Wadsworth Boulevard Widening Value Engineering Study Report

City of Wheat Ridge Public Works

The 3.5-day Value Engineering Workshop was held from April 30th to May 3rd, 2018 at City of Wheat Ridge City Hall located at 7500 W 29th Ave, Wheat Ridge, CO 80033. The VE Study was undertaken in accordance with the Colorado Department of Transportation (CDOT) Value Engineering Guidelines as well as the SAVE International Value Engineering Job Plan, which includes three stages: (1) Pre-Workshop, (2) Workshop, and (3) Post-Workshop.

| VE PROPOSAL VE-1 | |

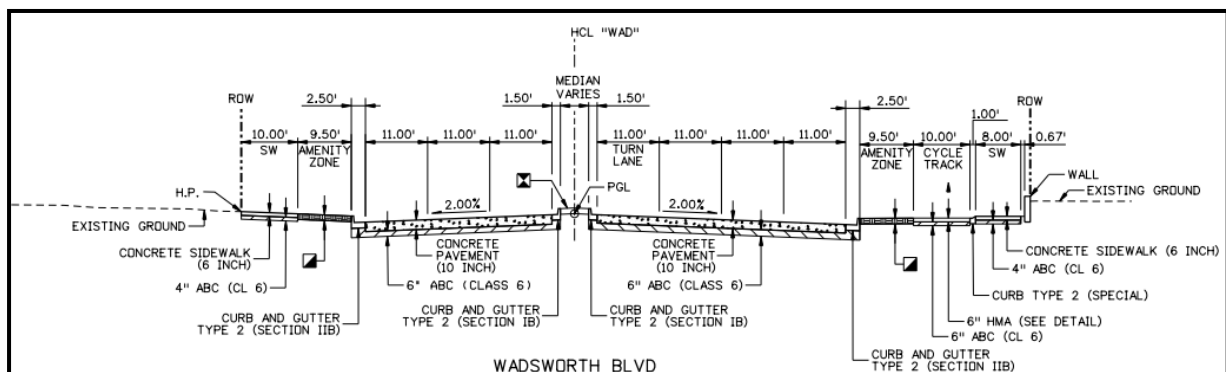
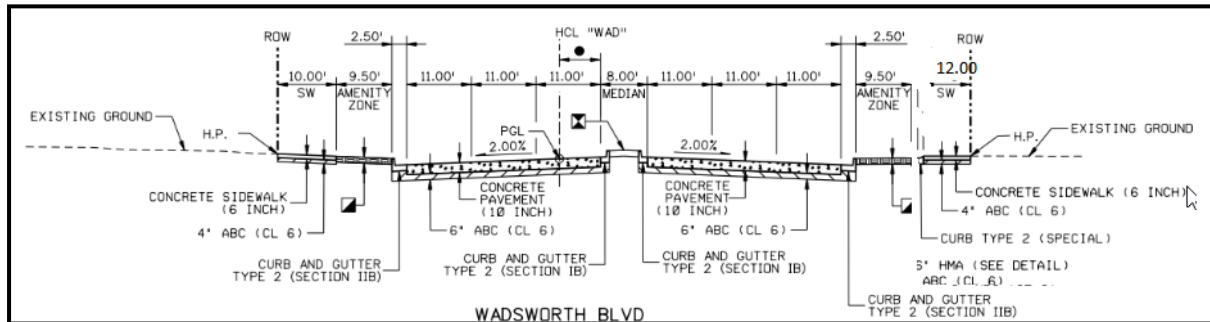
Remove the two way cycle track from 35th to 44th and widen the proposed sidewalk to a 12 foot wide shared path.

| DESCRIPTION OF VE PROPOSAL: Use a multi-use trail on the east side of the corridor in lieu of separate bike and ped facilities | Page No. 2 of 2 Prepared By: Russ Higgin/Stephen McQuilkin |

| DESCRIPTION OF VE PROPOSAL: Use asphalt in lieu of concrete throughout the project | Page No. 20 of 2 Prepared By: J. Hampton |

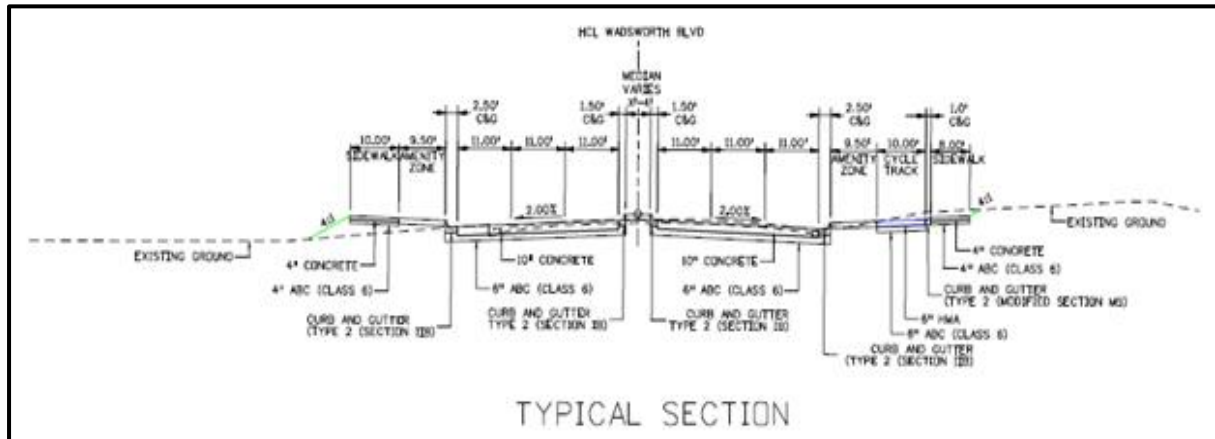
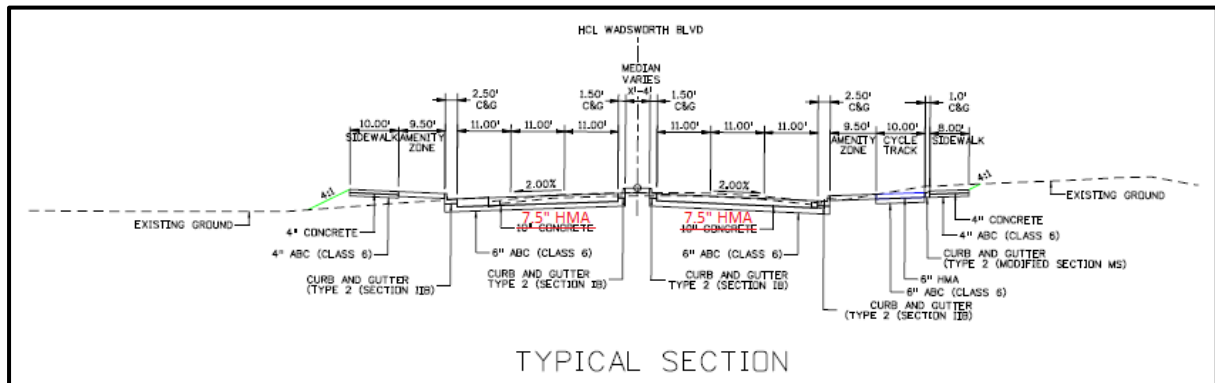
Using the provided pavement design report, the proposed design change would include a 7.5-inch thick HMA Pavement section throughout the project. There is no proposed change to base materials as a 6-inch section of ABC Class 6 is required for both.

| DESCRIPTION OF VE PROPOSAL: Reduce median width throughout the corridor | Page No. 2 of 3 Prepared By: Stephen McQuilkin |

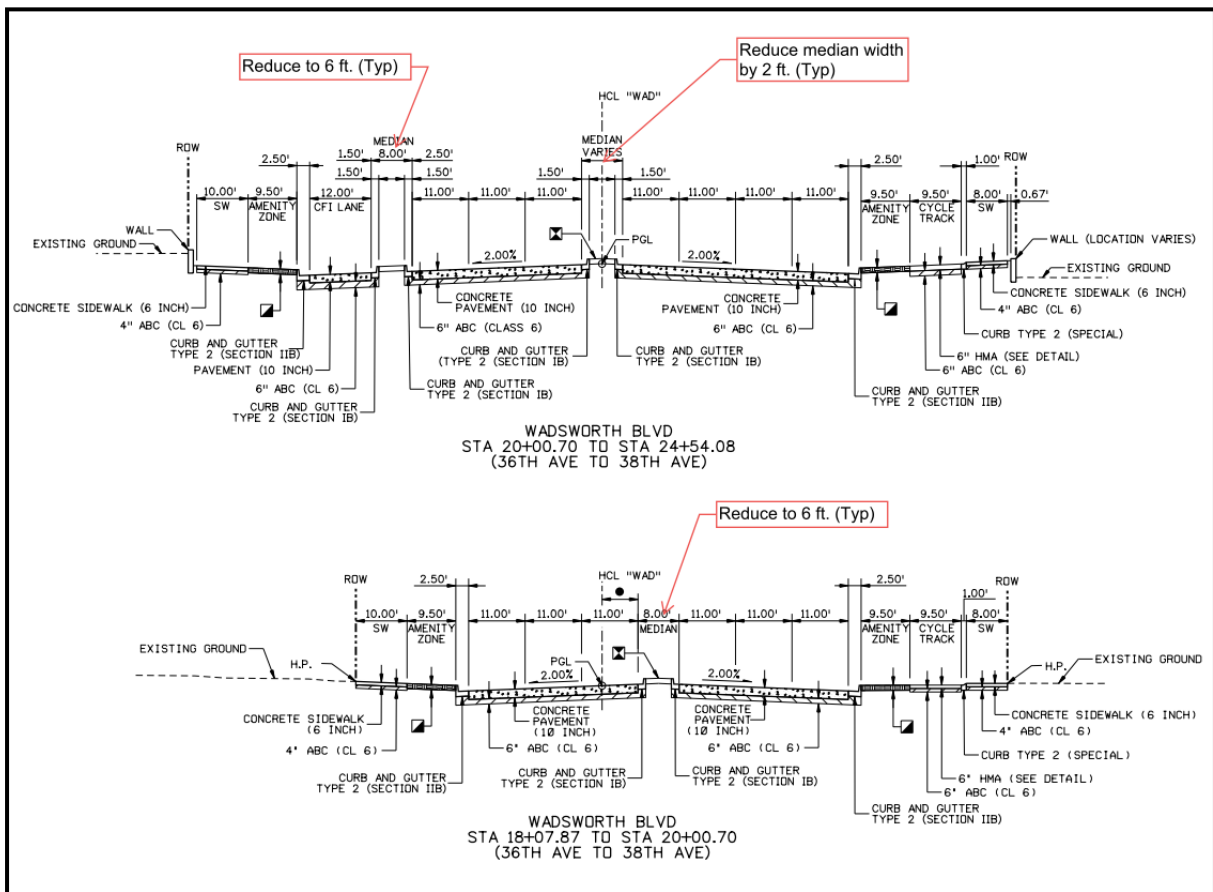
1 ft. Median Reduction

| VE PROPOSAL VE-7 | |

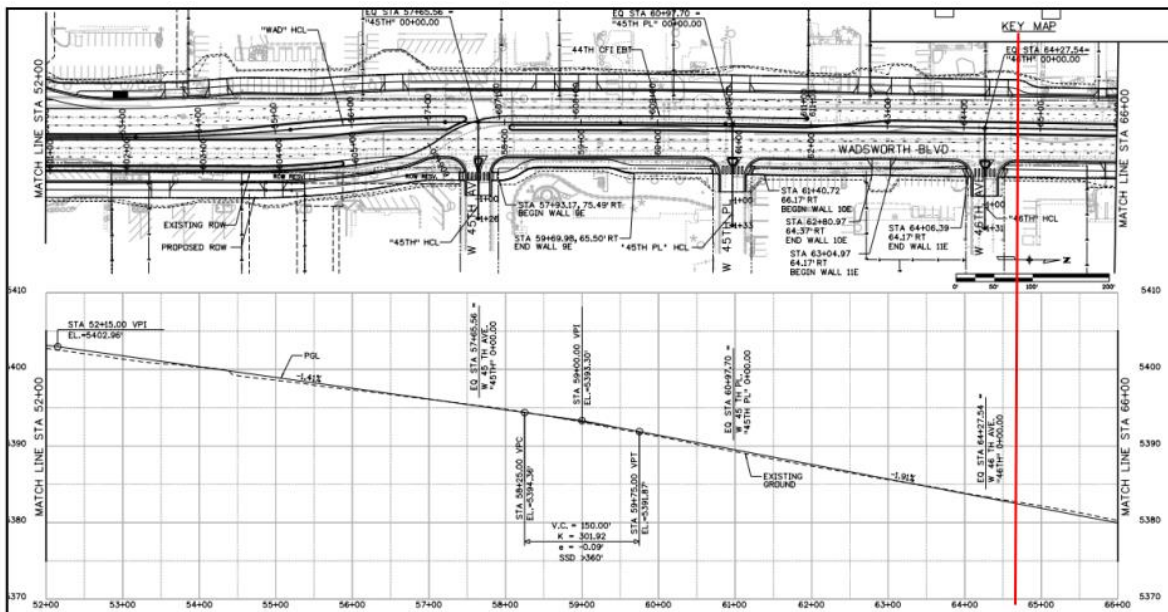
End Construction Limits at Approximately Sta. 64+60.

| | | Prepared By: J. Hampton | |

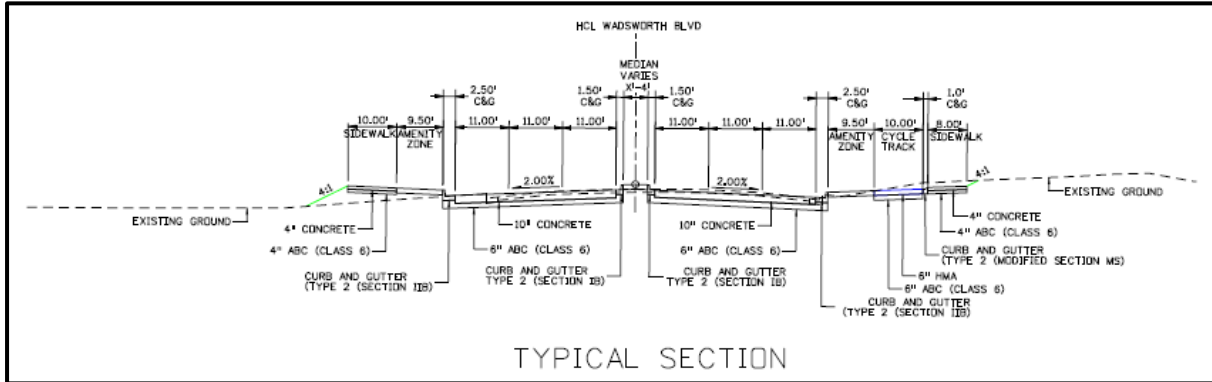
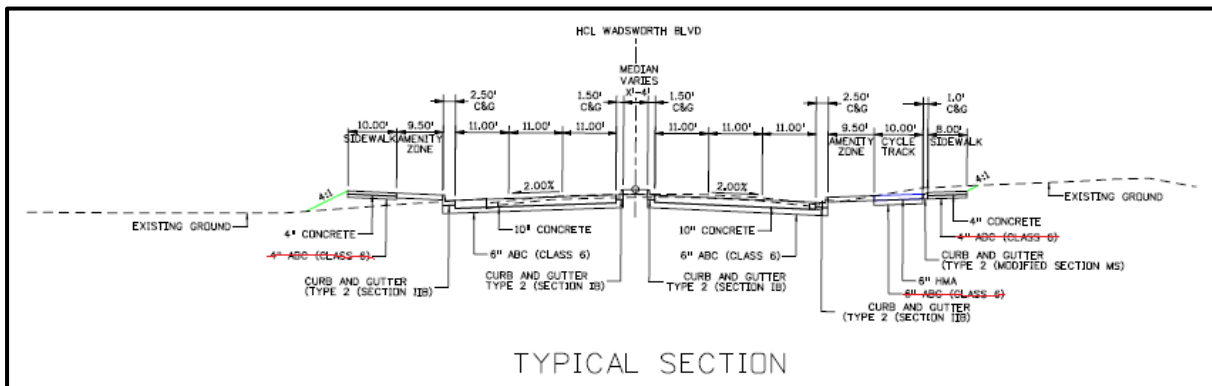
The largest benefit for the elimination of the ABC layers from under the sidewalks and cycle tracks is the cost savings in reduction of ABC and unclassified excavation quantities. The potential drawback of substandard subgrade under the sidewalk is mitigated by evidence presented in the Pavement Design Report that states the soil types as silty sand and clayey sand. These soil types are stable when compacted and would provide suitable subbase for concrete sidewalk. Additionally, the drainage through sand would mitigate the potential water issues from the amenity zone.

The typical sections would have to be amended to remove this requirement. Additionally, a Project Special Provision would need to be added to amend CDOT Standard Specification Section 608.04 Bituminous Sidewalks and Bikeways, Subsection (b) *Bed Course*.

| VE PROPOSAL VE-10 | |
|---|--|
| DESCRIPTION OF VE PROPOSAL: Eliminate traffic islands and right turn lanes at 38 th and 44 th | Page No.: 2 of 3 Prepared By: Steve McQuilkin |

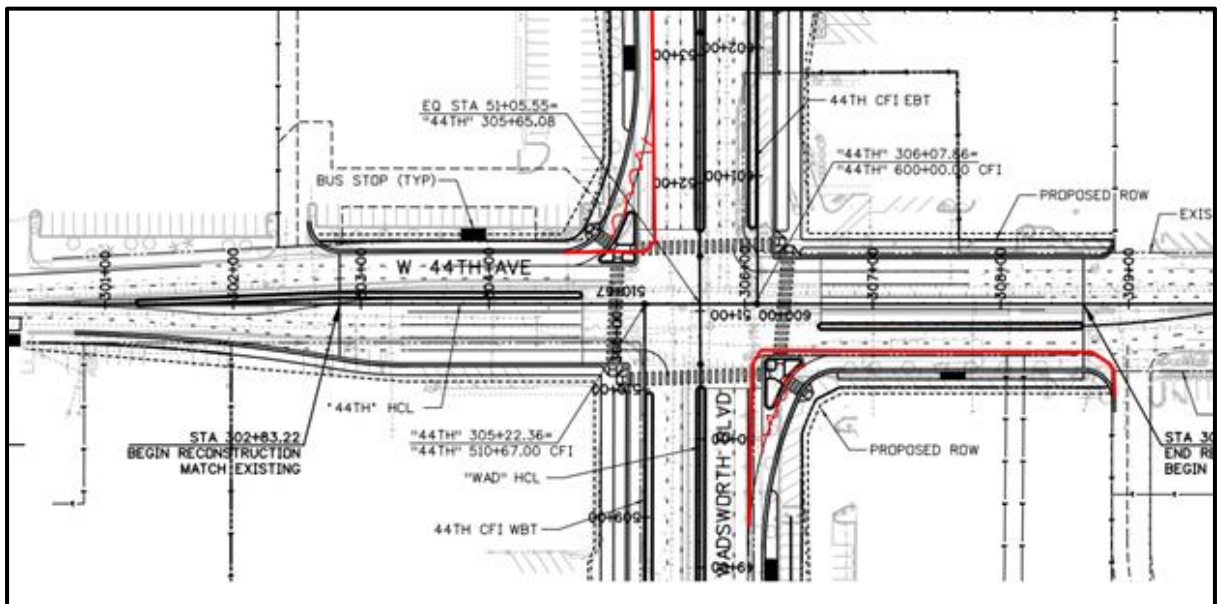
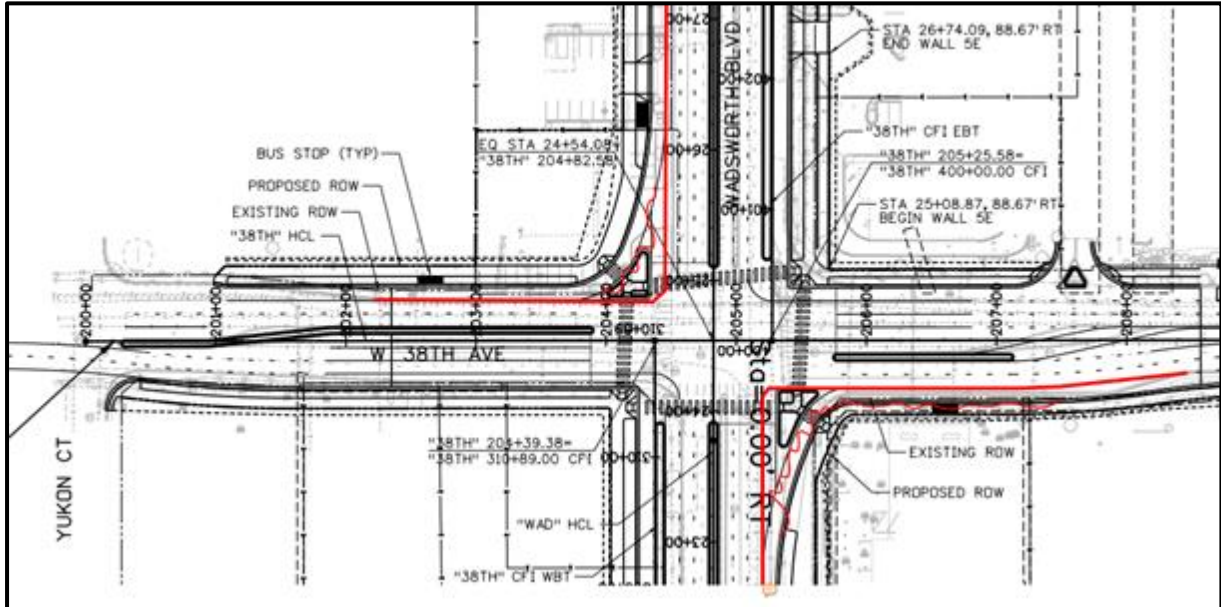
Original design includes right turn lanes and traffic islands for the Wadsworth NB and SB right turns at both 38th and 44th Avenues. These right turn lanes allow for free right turns at these locations as well as provide an area of refuge for pedestrians crossing Wadsworth and also for an impromptu “Q-jump” lane for NB and SB busses at these intersections.

| DESCRIPTION OF VE PROPOSAL: Eliminate the exclusive right turn lanes on the east and west legs of 44 th Avenue and the east leg of 38 th Avenue | Page No. 2 of 3 Prepared By: Gary Huber and Russ Higgins |

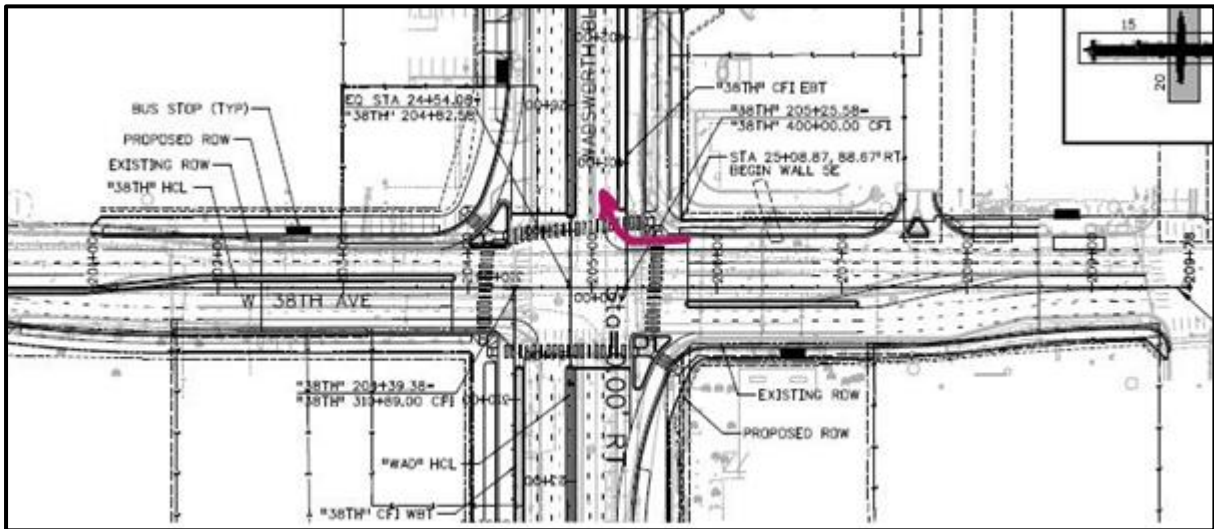
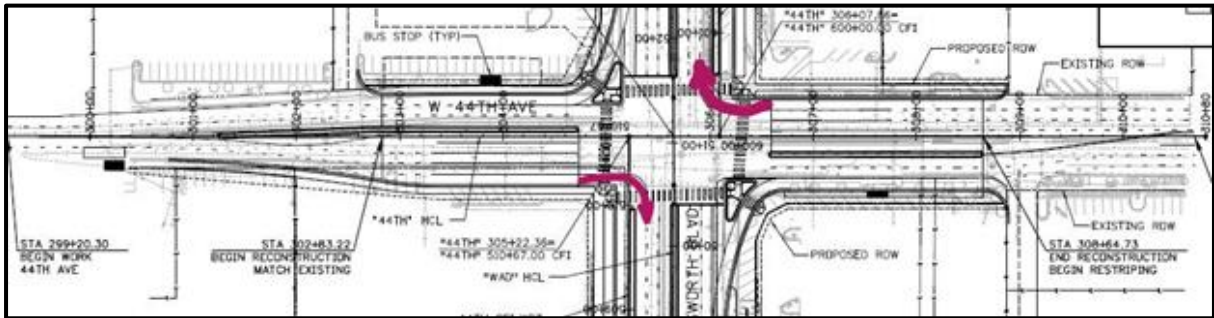
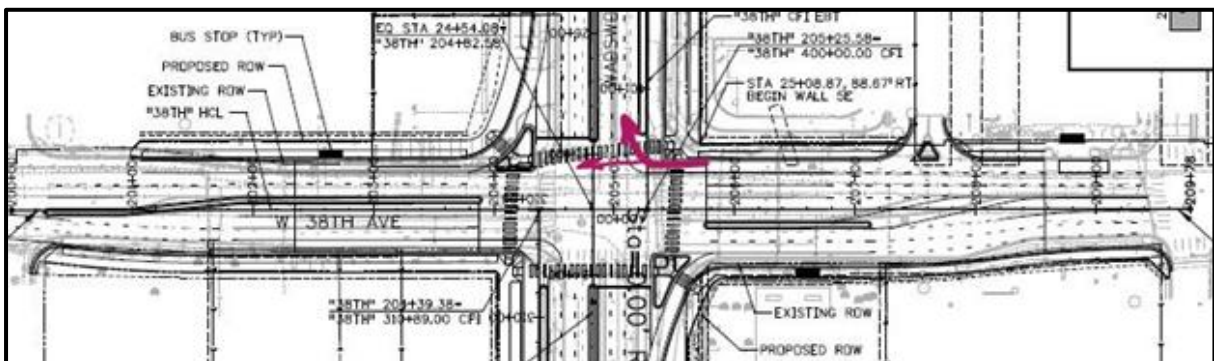
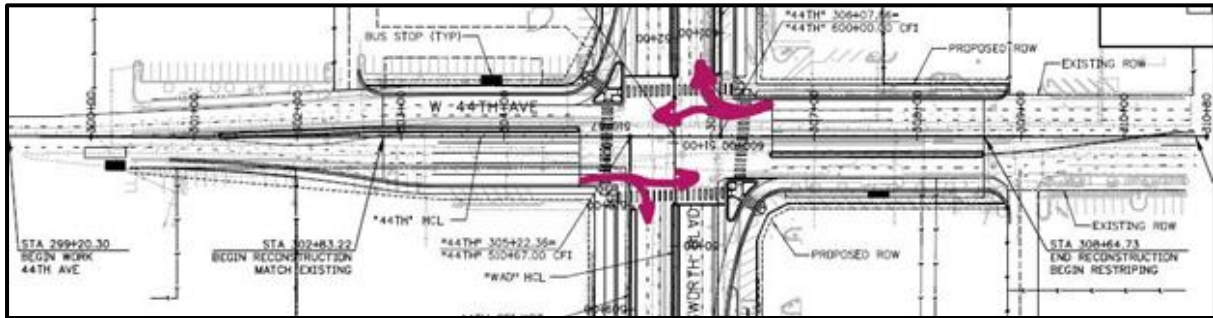
Eliminate the exclusive right turn movements at 44th in both directions and at 38th on the east leg and provide optional right and thru movements in all of these locations.

Cost of widening is on south edge of 44th Avenue for the west turn lane and the east acceleration lane. 44th Avenue lanes would be shifted to the north by one lane in the proposed design VE proposal.

| VE PROPOSAL VE-12 | |

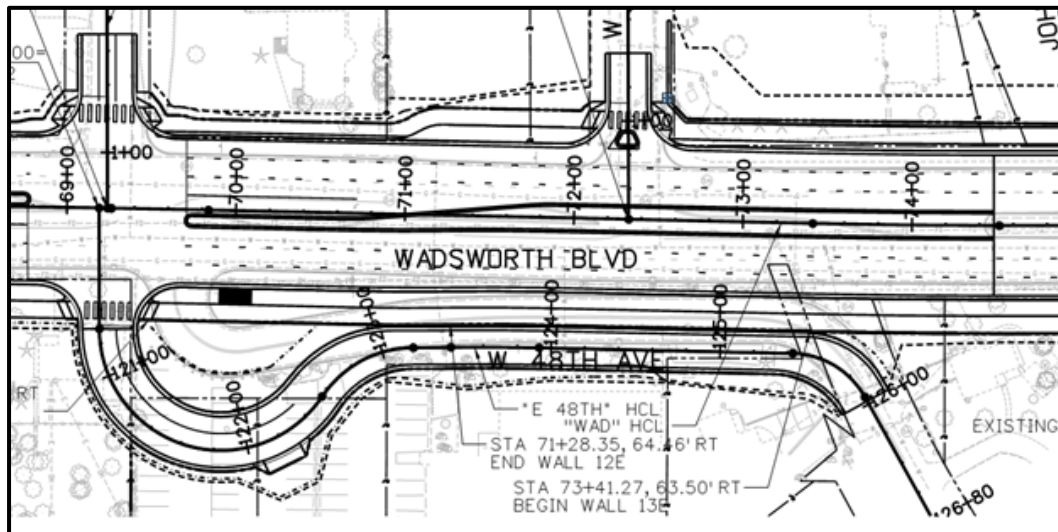
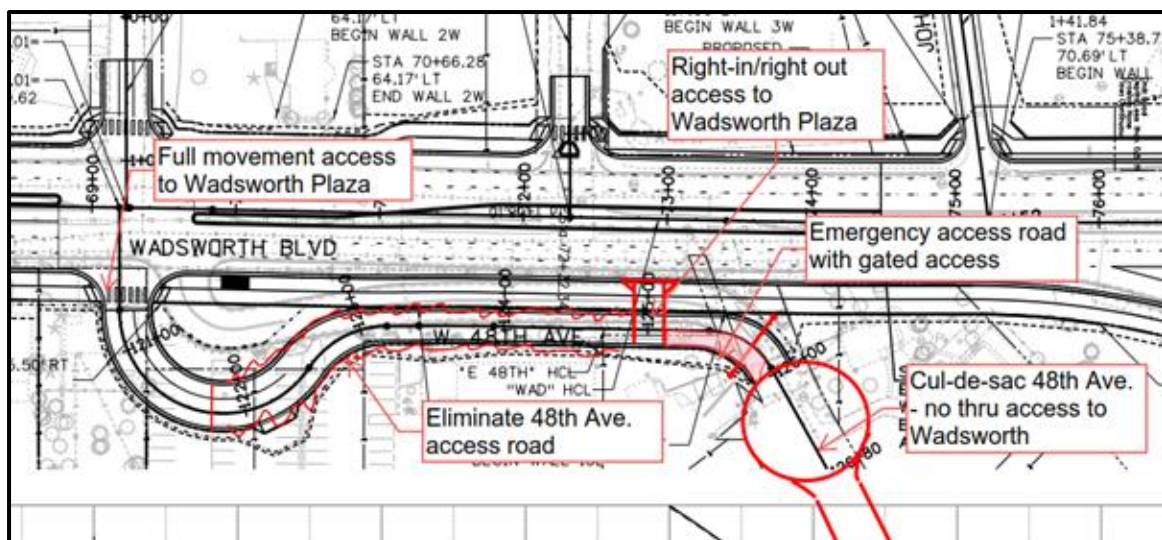
Maintain full movement access to Wadsworth Plaza and Glazar property at the 47th Ave. intersection. Eliminate the 48th Ave. access road through the Wadsworth Plaza property and provide an additional right-in/right-out access to Wadsworth Plaza at Sta. 72+80+/- . Construct cul-de-sac at the west end of 48th Avenue to eliminate access to Wadsworth through the Wadsworth Plaza property. Local access to Wadsworth from 48th will be diverted to 44th Ave. Provide a gated emergency access between Wadsworth Plaza and 48th Ave.

| VE PROPOSAL VE-15 | |
|--|---|
| DESCRIPTION OF VE PROPOSAL: Reduce the sidewalk width to 5 feet in front of the Johnson Park | Page No. 2 of 2 Prepared By: Paul Scherner |

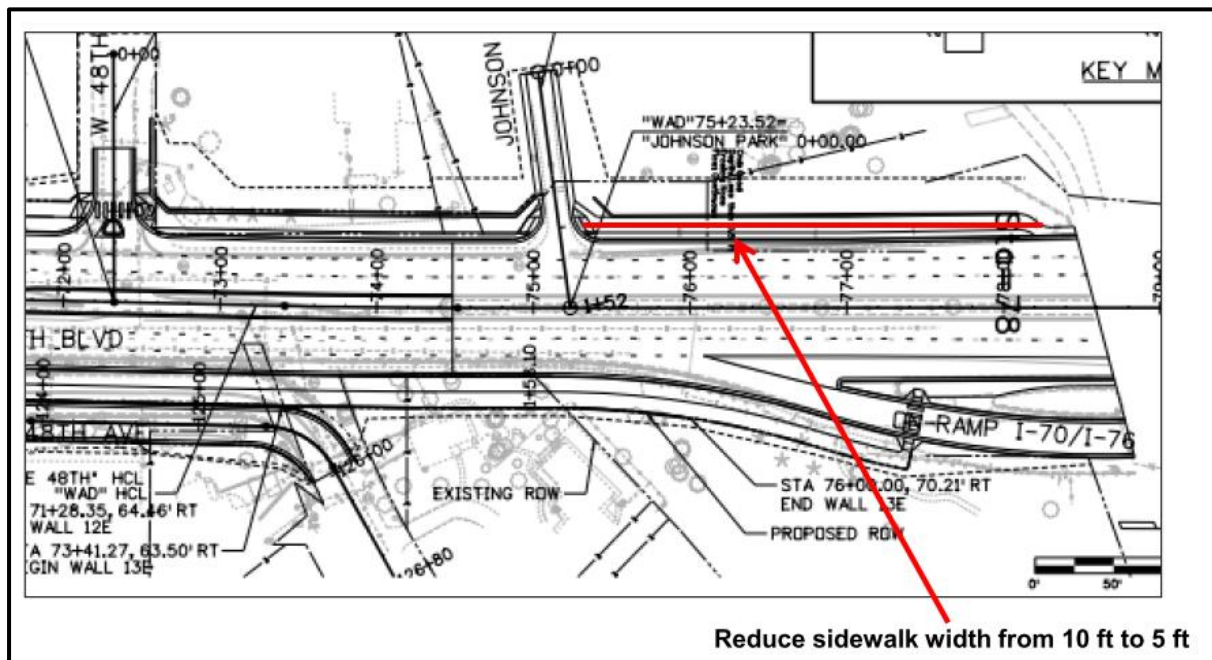
The proposed change matches the current width of the sidewalk north of the project limits where the I-70 interchange begins.
